HILL VALLEY - PHASE 2B

CITY PROJECT NO. 15860
CONTRACT NO. 9680

REVISION 1 - 04/29/26

REVISION 2 - 05/28/26

15860
 O-1

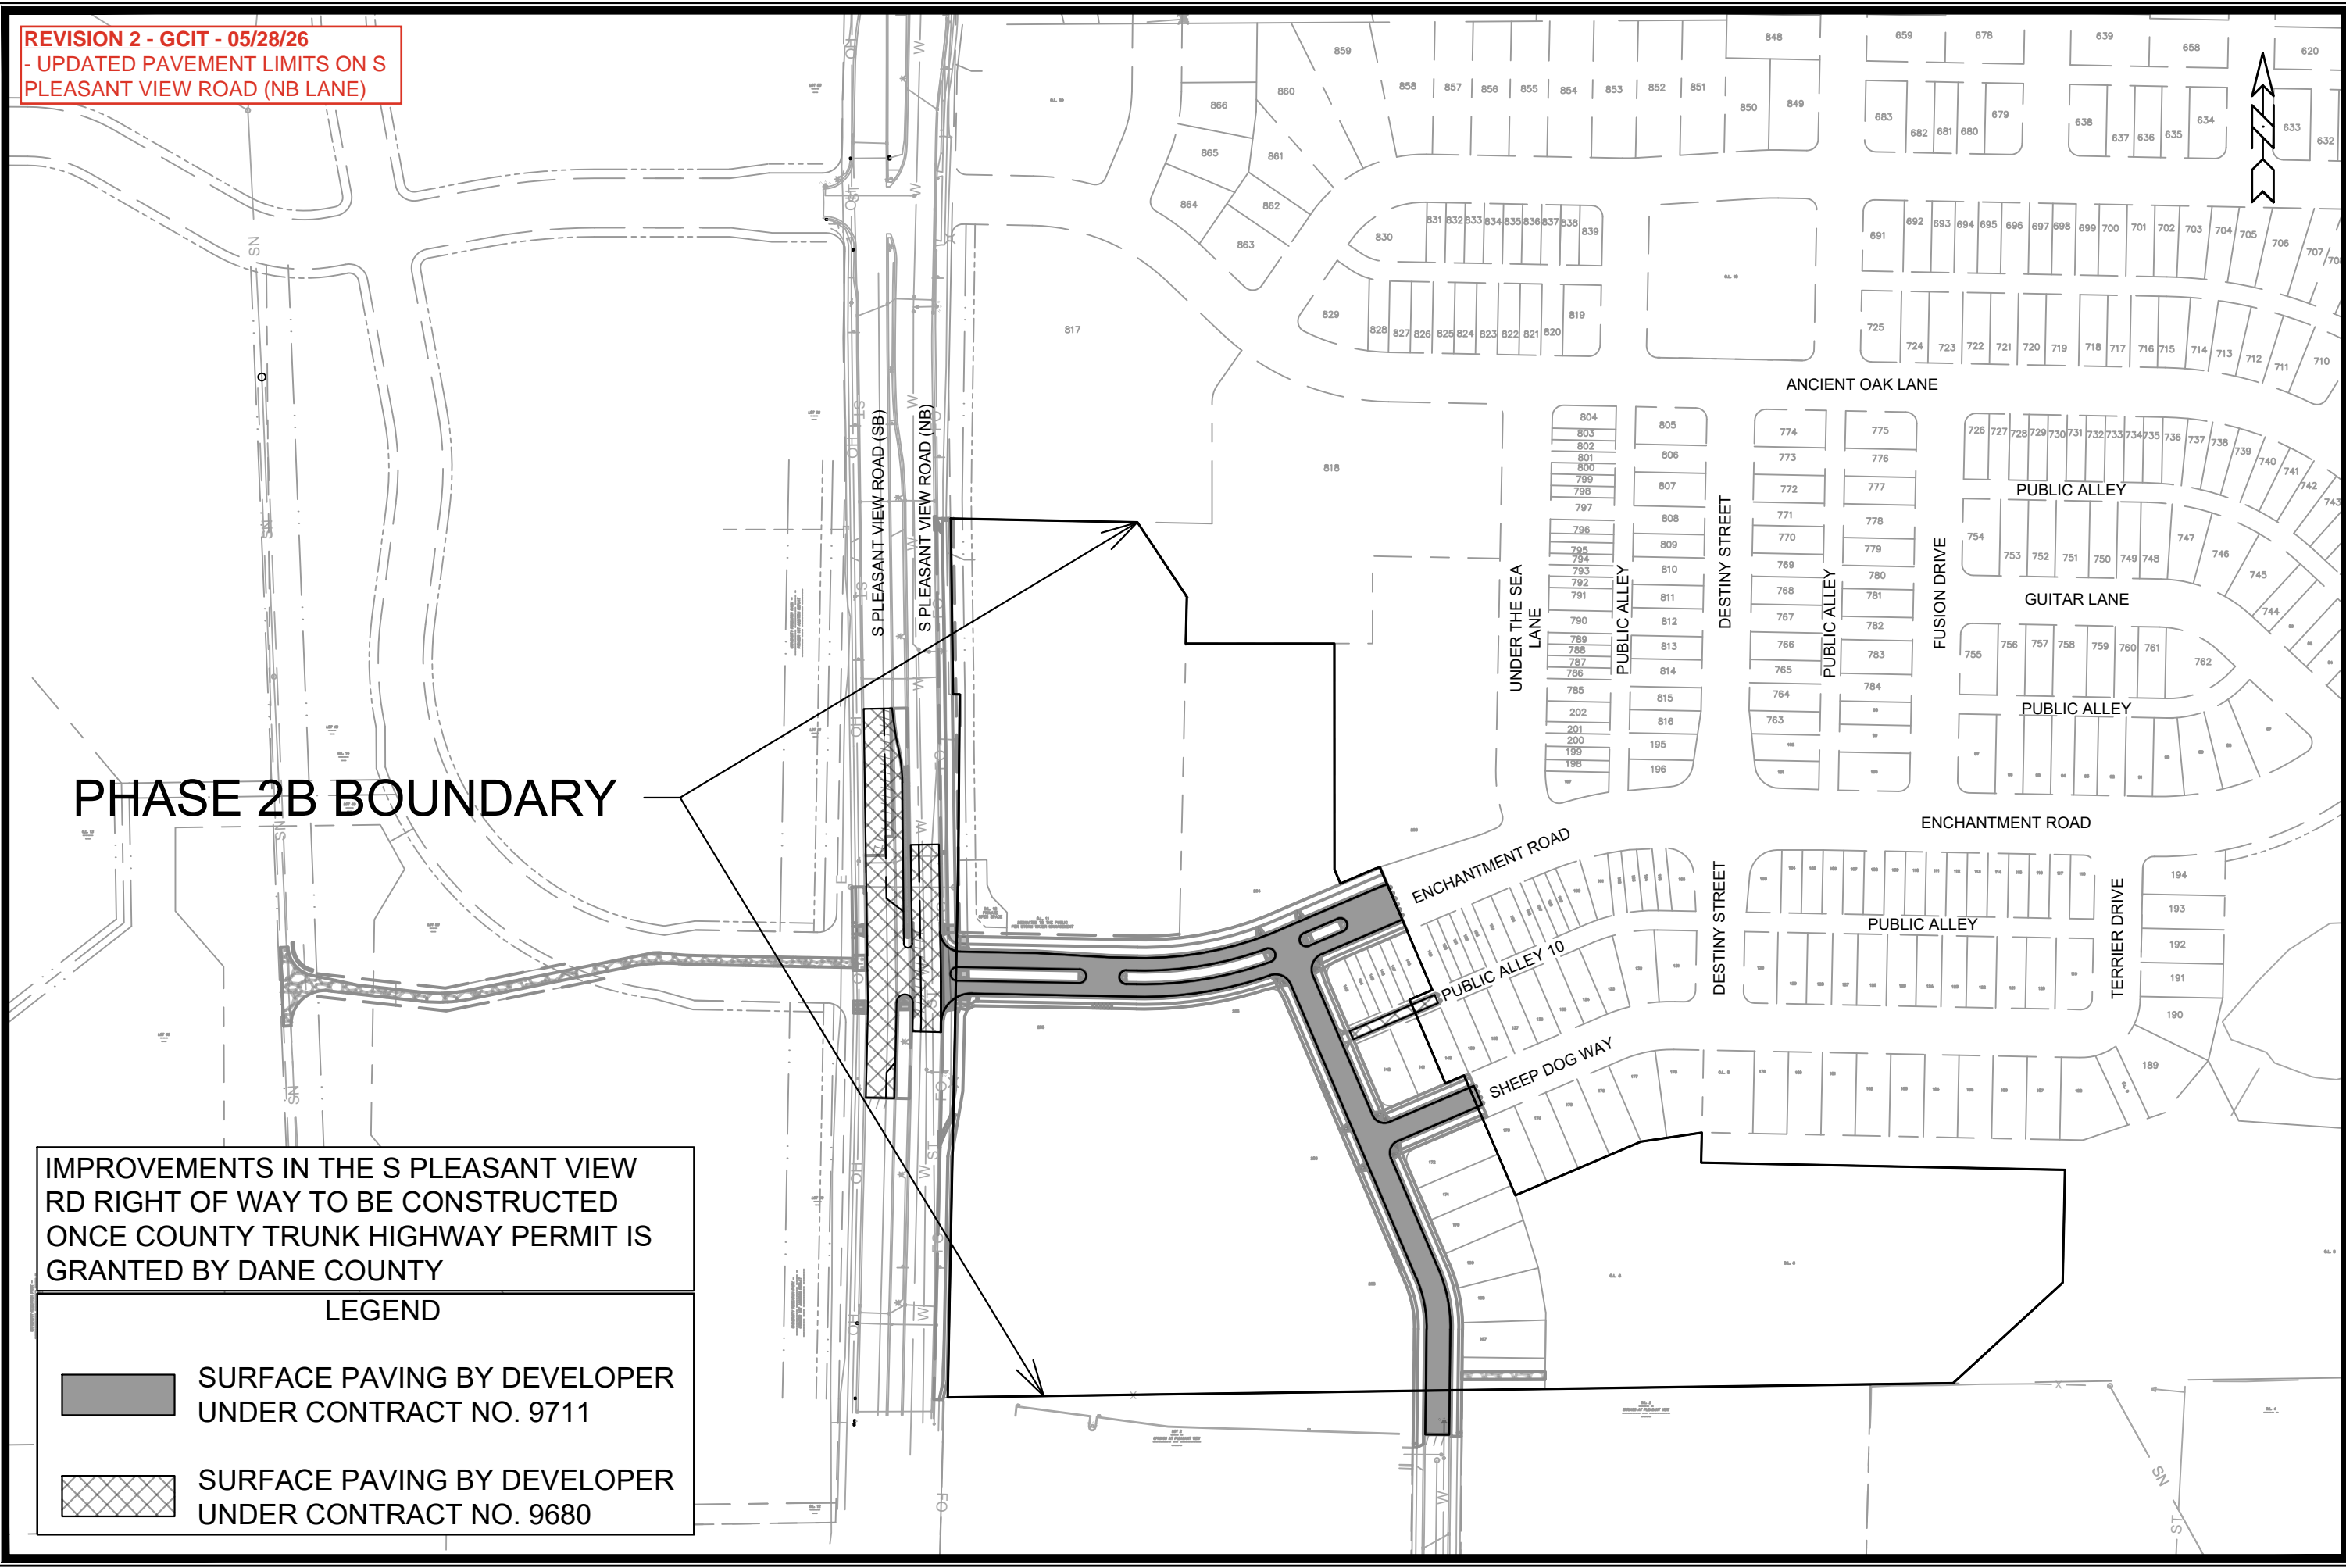
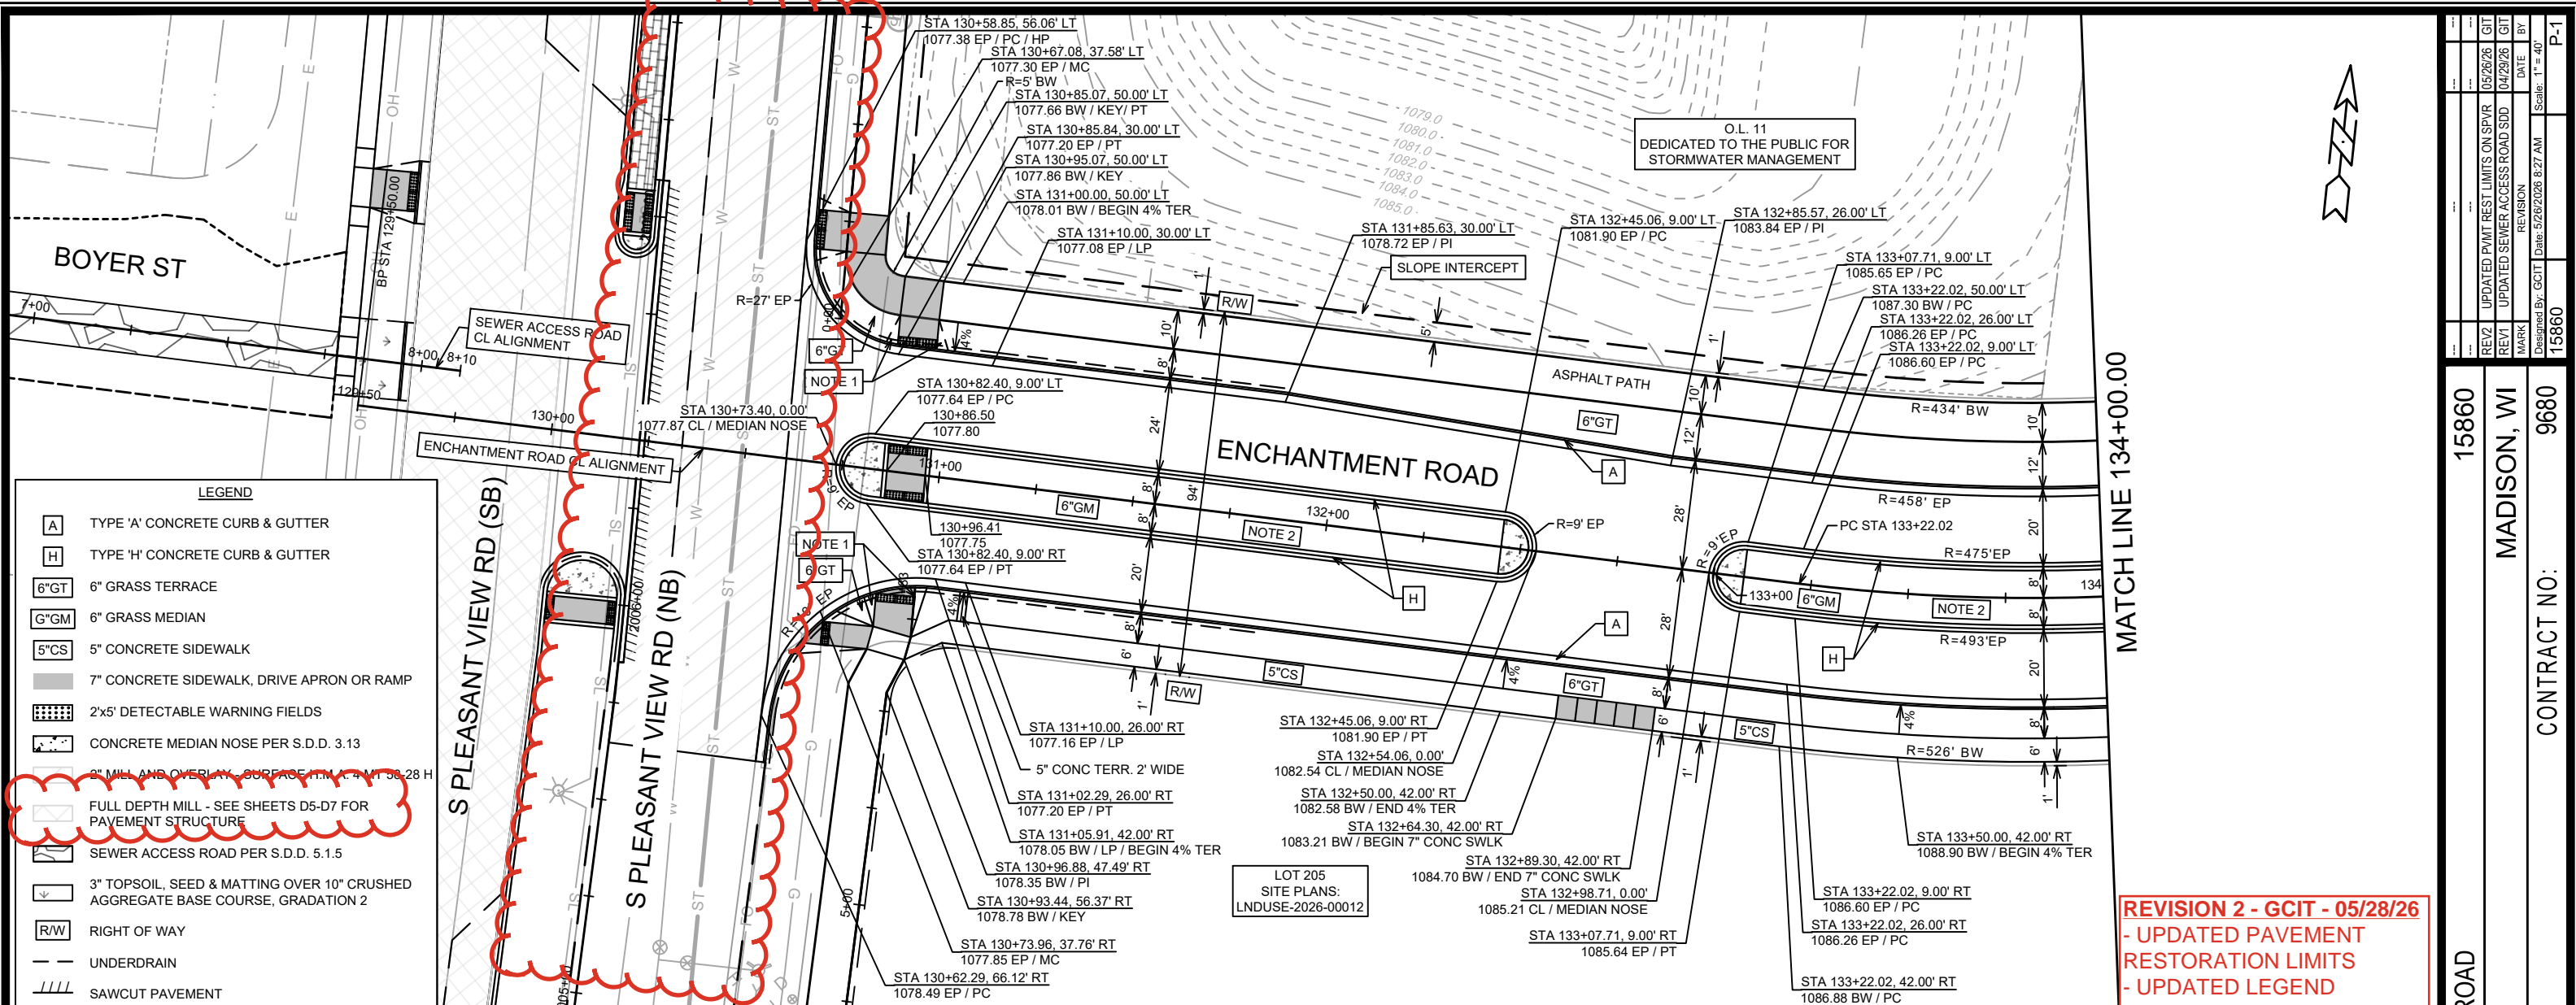
REVISION 2 - GCIT - 05/28/26
 - UPDATED PAVEMENT LIMITS ON S PLEASANT VIEW ROAD (NB LANE)
